Updates in draft-ietf-raw-architecture-17

contribution to DetNet WG

IETF 119

New Figure 3 “Wireless layer and DetNet sub-layers”

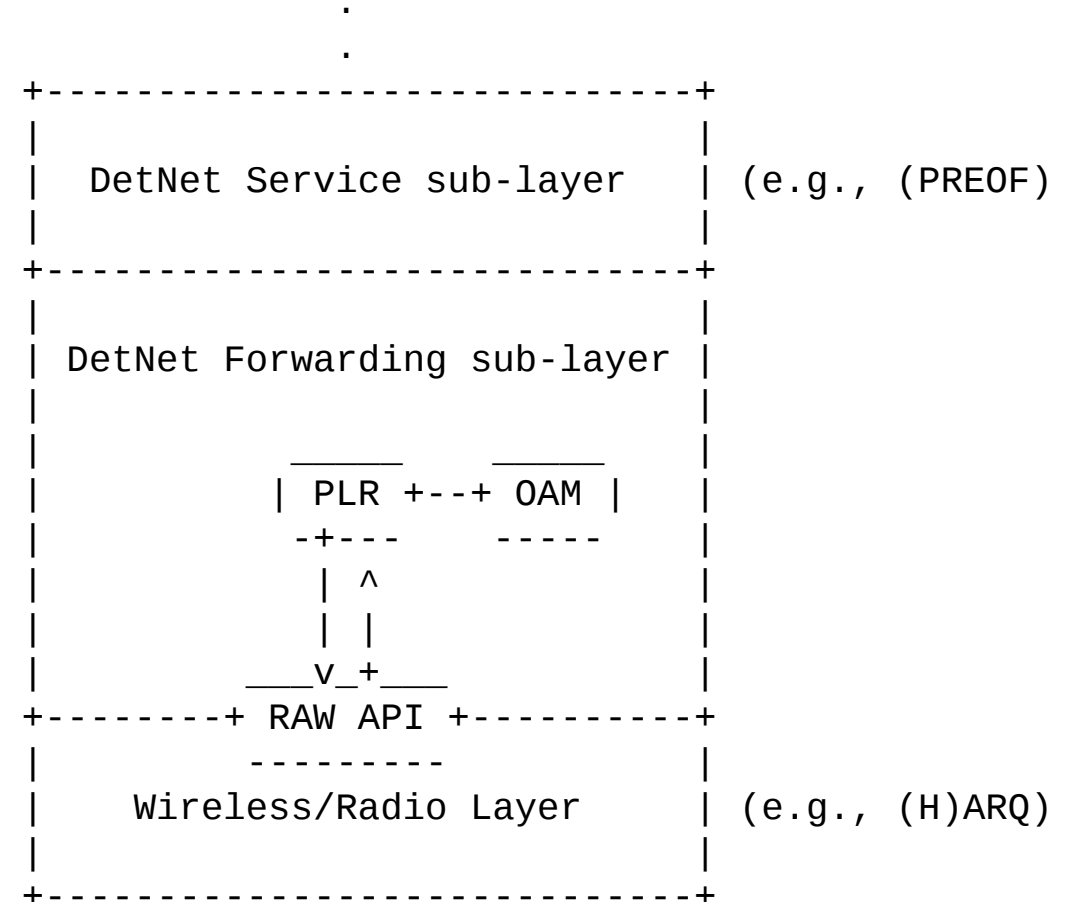
- Proposed in review of v16
- Basic idea:
simple illustration of the essence
of new aspects RAW brings to
DetNet
(based on [Figure 4](#) in RFC 8655
DetNet Architecture)
